**RE: REQUEST FOR ADDITIONAL INFORMATION
DA-28/2022
20 HUME HIGHWAY, WARWICK FARM
LOT 11, DP 1204506**

REQUEST FOR ADDITIONAL INFORMATION

ADDRESS: LOTS 11 & 12 DP 1204506
20 HUME, WARWICK FARM
DESCRIPTION: CONSTRUCTION OF A 10-STOREY RESIDENTIAL FLAT
BUILDING COMPRISING 28 RESIDENTIAL UNITS ABOVE
TWO LEVELS OF BASEMENT CAR PARKING, TOGETHER
WITH VEHICLE ACCESSED LANDSCAPING AND
ASSOCIATED WORKS. THE APPLICATION IS SUBMITTED
UNDER THE STATE ENVIRONMENTAL PLANNING POLICY
(HOUSING) 2021

**MINUTES OF DESIGN EXCELLENCE PANEL MEETING
Thursday the 11th of May 2023**

3. Overshadowing / Scale of Building

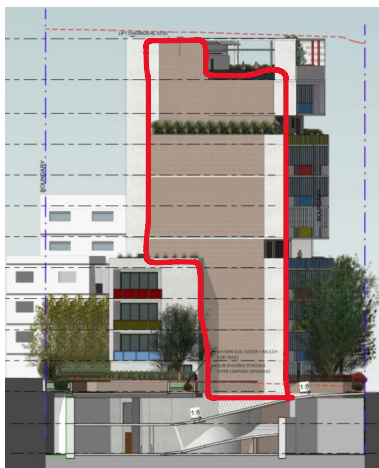
The development results in additional overshadowing to southern-adjoining sites. Given the height proposed and the orientation of the site, overshadowing of the southern adjoining development is inevitable. The plans, however, do not provide an in-depth assessment of the extent of additional overshadowing that would occur, and in this regard, such shall be provided given that ADG separations are not met.

Whilst the proposal is within the allowable building of 35m, a 10-storey building as proposed results in excessive overshadowing of adjoining properties and is inconsistent with scale of the adjoining 5-6 storey residential apartment buildings. In order to minimise the extent of shadow impacts upon neighbouring sites, the reduction of the overall height and scale of the building is encouraged.

Alternatively, should the height not be reduced, an in-depth analysis should be provided to clearly delineate the extent of overshadowing for every hour during the winter solstice and provide an additional hourly analysis for later in the year, between September to December to justify any departure from the control.

The scale of the development is within the appropriate limitations applicable to the site (i.e. 35.0m LEP standard). An in-depth analysis of solar access has therefore been prepared by way of hourly sun-eye diagrams for the winter solstice, and the equinox (Drawings DA-700 through to DA-723).
